CITY OF PORTLAND, MAINE

Project Name: "118 on Munjoy Hill" Condominium
12 unit residential, and 2 unit commercial, condominium
Project ID: #2013-255
Project Address: 118 Congress Street
CBL: 16-D-2
Applicant: Ed Theriault, EMT, LLC (118 Condominiums, LLC)
Planner: Jean Fraser

On January 28th, 2014 the Portland Planning Board considered and approved a Level III Final Site Plan and Subdivision proposal for the construction of a 4-story 14 unit condominium building at 118 Congress Street, comprising 2 commercial units totaling approximately 1800sq ft floor area, 18 parking spaces on the ground floor to the rear of the commercial units, and 12 residential units above.

1 | PARKING LEVEL
PROJECT FOOTPRINT: 8,884 GSF

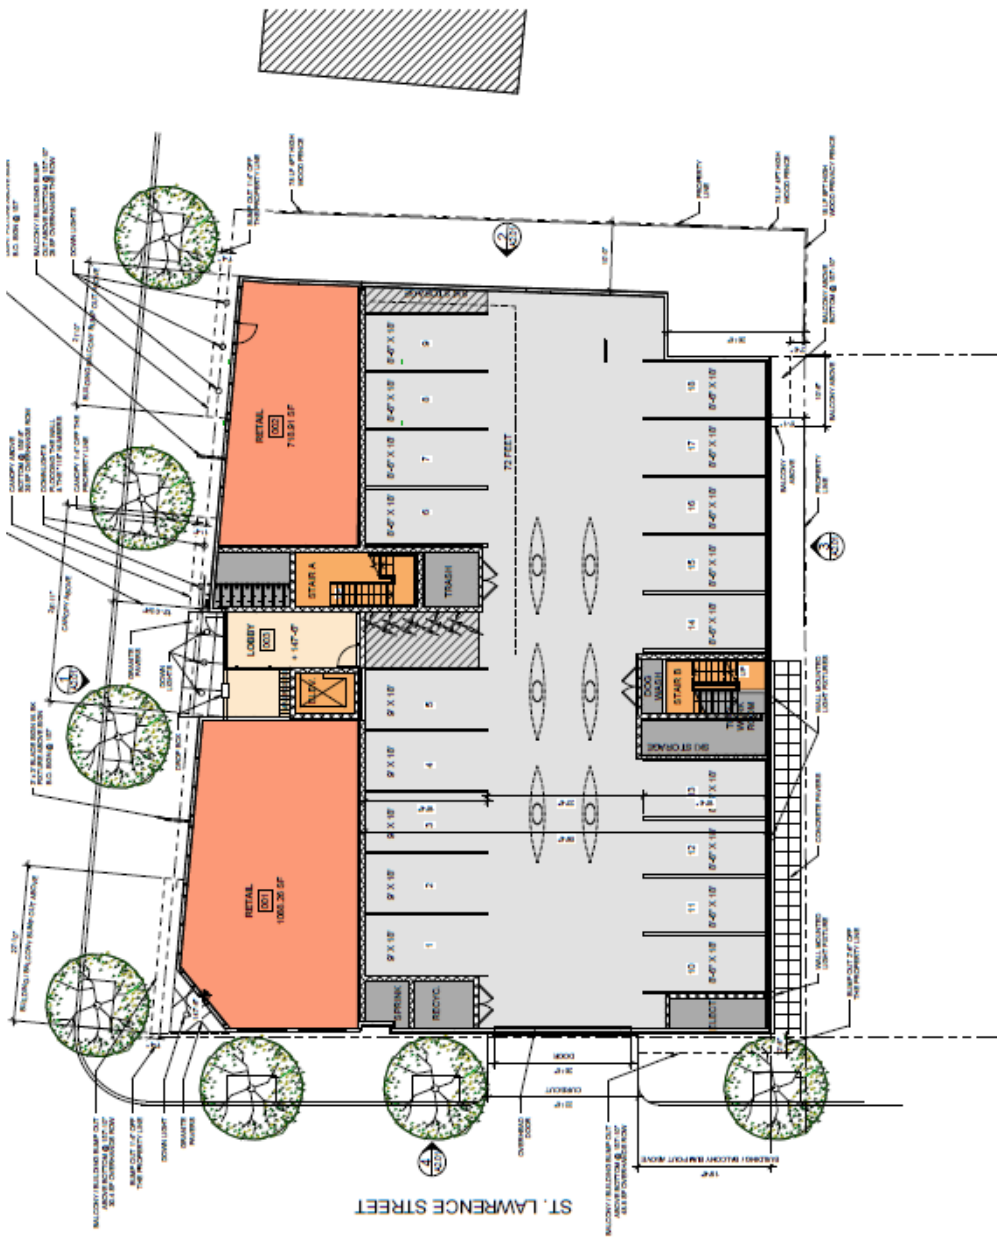
1. The Planning Board voted 7-0 to waive the Technical Design Standard Section 1.14 *Parking Lot and Parking Space Design* to allow for 13 of the indoor parking spaces to measure 18 feet by 8'6".
2. The Planning Board voted 7-0 to waive the Technical Design Standard Section 1.14 *Parking Lot and Parking Space Design* to allow a drive aisle of less than 24 feet, as shown on Plan P12.

Status: In addition to the request for a parking stall dimension waiver, the applicant is also requesting a waiver for a reduction in parking aisle width from 24 feet to 23 feet. I support waivers from these City standards.
